**MEMORANDUM**

**SUBJECT:** **Setdown Report** for ZC #04-14B, Florida Rock Properties, Inc., et al – PUD Modification @ Square 708, Lot 14

*Proposed Residential Building from Potomac Avenue*

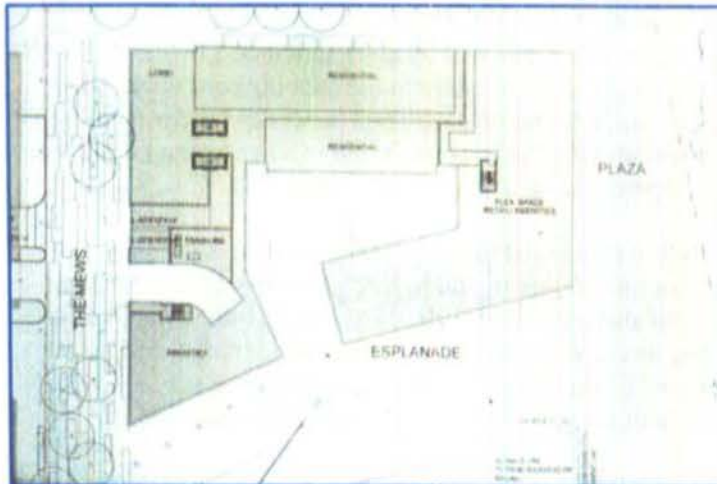
The East Office Building is now proposed to be a predominantly residential building at 94.85 feet in height, 46% lot occupancy and 1.2 FAR<sup>2</sup>. The ground floor would have 12,500 sf of space dedicated to retail uses, although, initially, 7,500 sf of that space is being requested as residential amenity flex space until the neighborhood retail market is more firmly established.

The residential building would include about 324 residential units. Eight percent of the residential gross floor area would be assigned to households making no more than 80% of the Annual Median Income (AMI). The affordable housing would be for the life of the project in accordance with the Inclusionary Zoning (IZ) provisions. The applicant will provide details of the distribution of the affordable units prior to a public hearing.

The building's U-shaped design is oriented towards the river to afford favorable views for the maximum number of units. The residential portion of the ground floor along Potomac Avenue would have residential entrances and small outdoor spaces intended to animate the street and improve the residential character of the building. The plan set provides various perspectives of the design (Pages 1.501- 1.504).

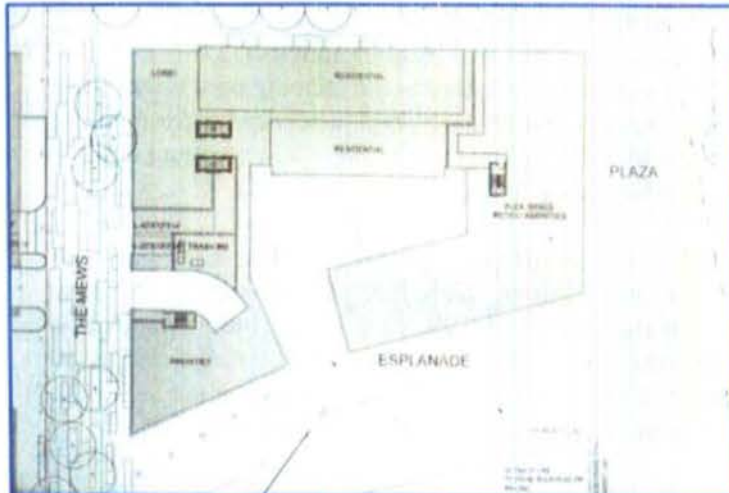
The amount of area devoted to retail has been reduced significantly, from over 80,000 sq.ft. in the approved plan to just over 23,000 sq.ft. in the current proposal. The applicant has hired a retail consultant to assess the viability of retail in the area. OP has encouraged the applicant to take a very proactive approach in the creation of vibrant retail space, but is supportive of the currently proposed amount as it provides for activation of the riverfront and the area across from the Ballpark entrance, and will compliment other retail nodes in the vicinity, particularly in the Yards development to the east. Should the future market warrant it, the applicant could request additional retail in future phases of development, particularly in the Phase III office building, as part of Stage 2 applications. OP is also very supportive of the applicant's desire to animate the waterfront with temporary market or retail spaces on portions of the site intended for future development. OP has advised that extensive surface parking on this land would not be supported.

In summary, OP supports the redesign of these phases, including the open space areas, as it reduces the visual massing and provides improved pedestrian and visual opportunities to the public in accessing the river's edge.
